Addendum #2

Attn: Estimator	Date: November 26, 2024
From: Lisa Donahue, Project Administrator	Pages: 25 (including cover page)
Re: Bullock Creek School District 2024 Bond Series 1	Project: 2025 Summer Projects HS/MS/Elem/Pine River/Floyd and Maintenance Building
CC:	Proj. #: A24907

ADDENDUM #2

Project: No. 24-120 2023 Bond – Series 1 2025 Improvements

DRAWING TITLE
**COOLER/ REFRIGERATOR
DEMOLITION PLAN,
FLOOR PLAN**

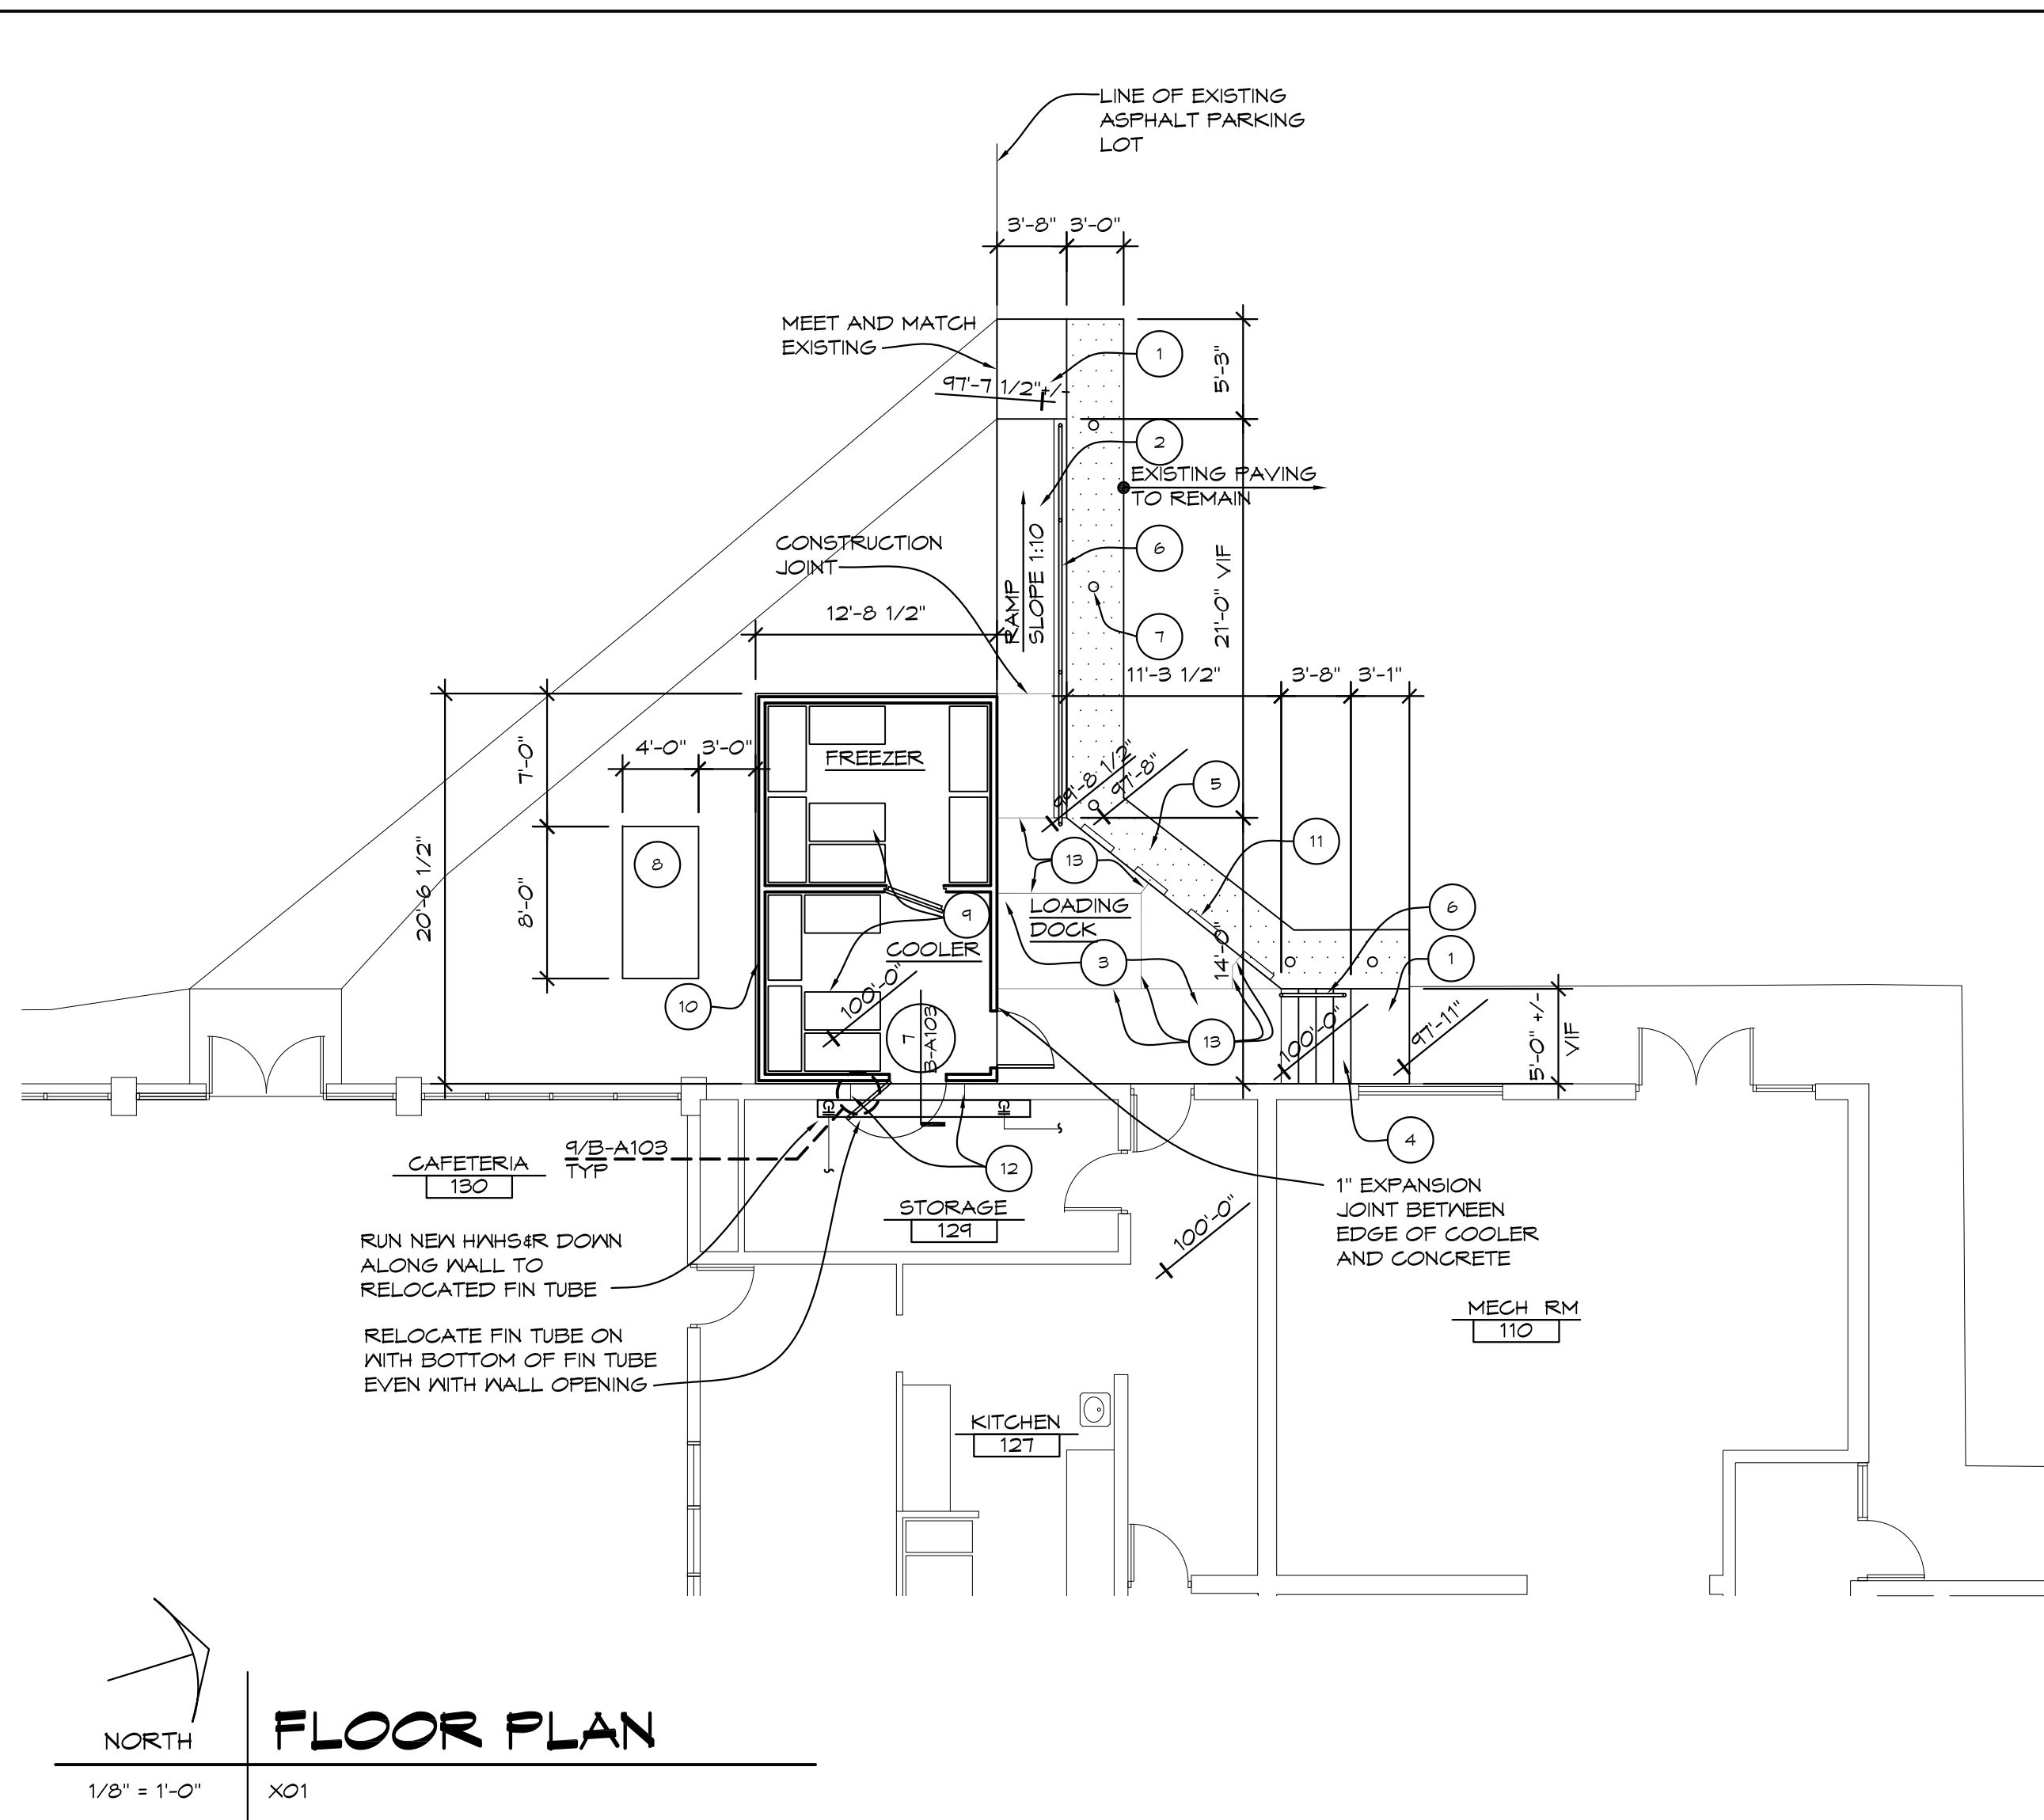
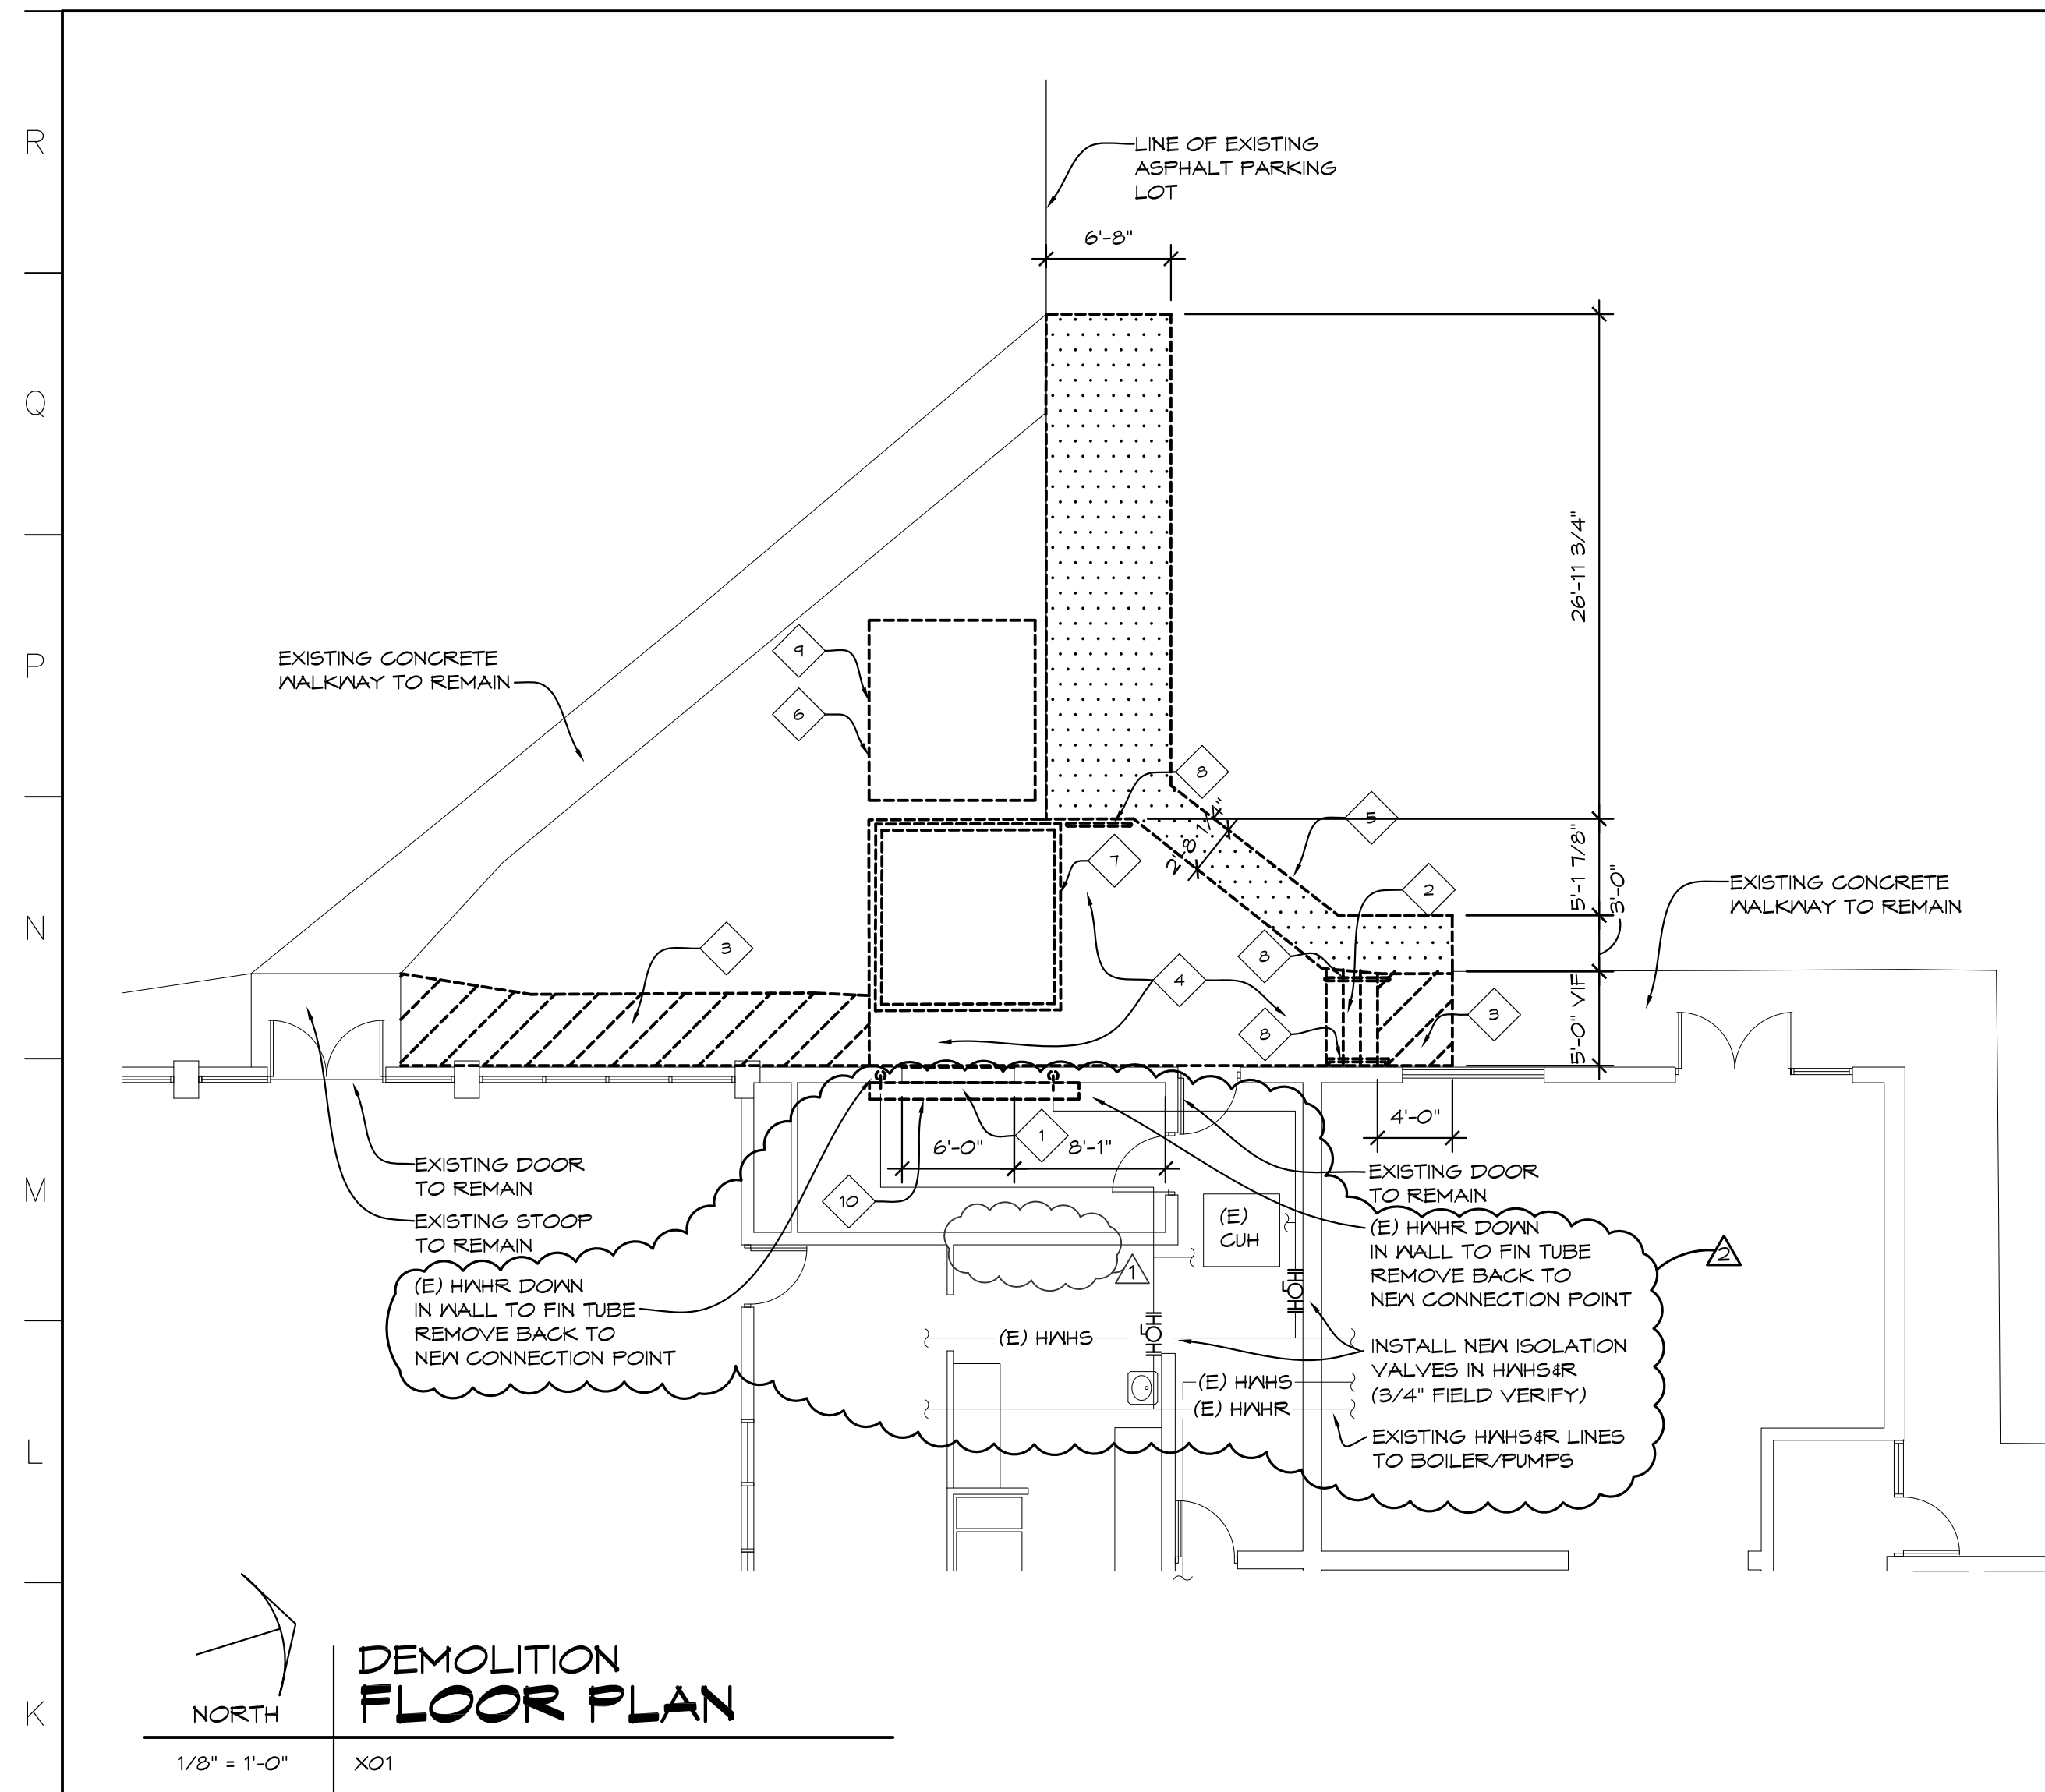
- Item #M1: Revise Sheet B-A102 as follows:
- a. Remove and reinstall existing fin tube in Storage 129 above door for new wall opening. Reinstall fin tube with bottom of enclosure even with new door opening. Re-pipe hot water heating supply and return to fin tube exposed down along wall.
 - b. Install new isolation valves in hot water heating supply and return lines feeding existing fin tube and cabinet unit heater.
